Work Order ID 119210

Item ID: D3394-1 Accept *N900040100* Setup Start *NS1*
Revision ID: Stop *NS2*
Item Name: Lug
Start Date: 5/14/14 Start Qty: 108.00 *108* Cust Item ID:
Required Date: 6/04/14 Req'd Qty: 108.00 *108* Customer:
Reference:

DRAWING NO. D3894	TITLE LUG	REV. B	DART AEROSPACE LTD ENGINEERING ORDER		D.E.O. NO. D3394-B-1	SHEET NO. SHEET 1 OF 1	SCALE NTS
DRAWN AJS	CHECKED	MFG. APPR.	APPROVED		DE APPR.		
DATE 09.11.04	DATE 09.11.04	DATE 09.11.04	DATE 09/11/04		DATE 09/11/04

DRAWING NO. D3394	TITLE LUG	REV. B	DART AEROSPACE USA, INC ENGINEERING ORDER		D.E.O. NO. D3394-B-2	SHEET NO. SHEET 1 OF 1	SCALE NTS
DRAWN JP	CHECKED SC	MFG. APPR. M	APPROVED AP		DE APPR. H		
DATE 11.05.02	DATE 11.05.09	DATE 11.05.09	DATE 11.05.09		DATE 11.05.09

SECTION A-A

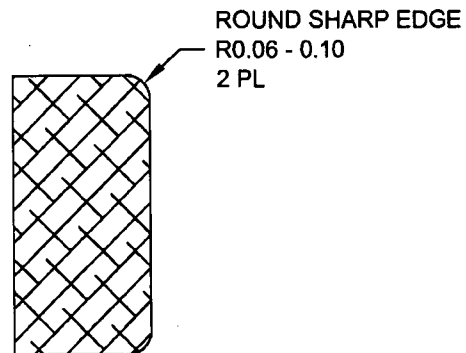
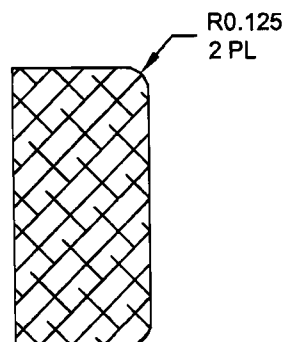
SHEET 4 ZONE A,1 MODIFY SECTION A-A AS SHOWN:

REASON: DRAFTING ERROR

IS:

WAS:

D3394-1RG LUG (SHOWN)
D3394-3RG/-5RG LUGS (SIMILAR)
D3394-041RG/-043RG/-045RG LUG ASSEMBLIES (SIMILAR)

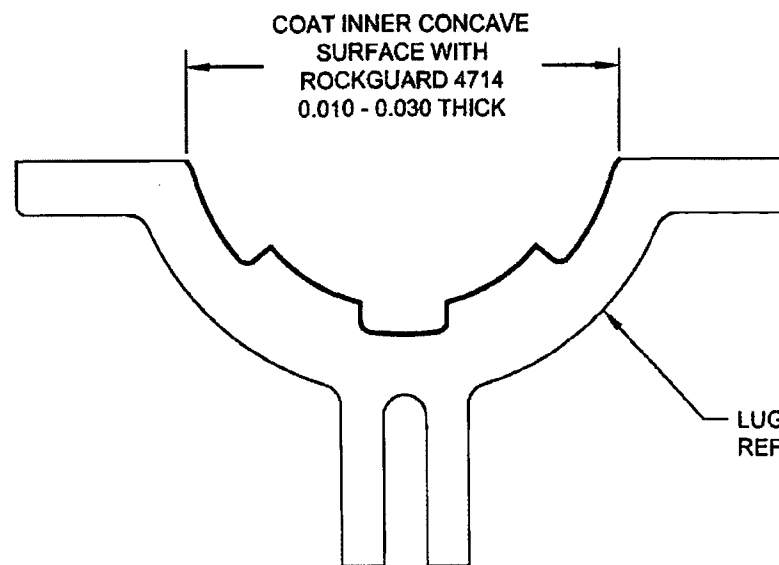
ADD D3394-xRG OPTION

D3394-xRG MOUNTING LUGS ARE IDENTICAL TO D3394-x MOUNTING LUGS, HOWEVER AFTER FINISH, COAT INNER CONCAVE SURFACE WITH "PLUS ONE ROCKGUARD 4714" AS SHOWN BELOW.
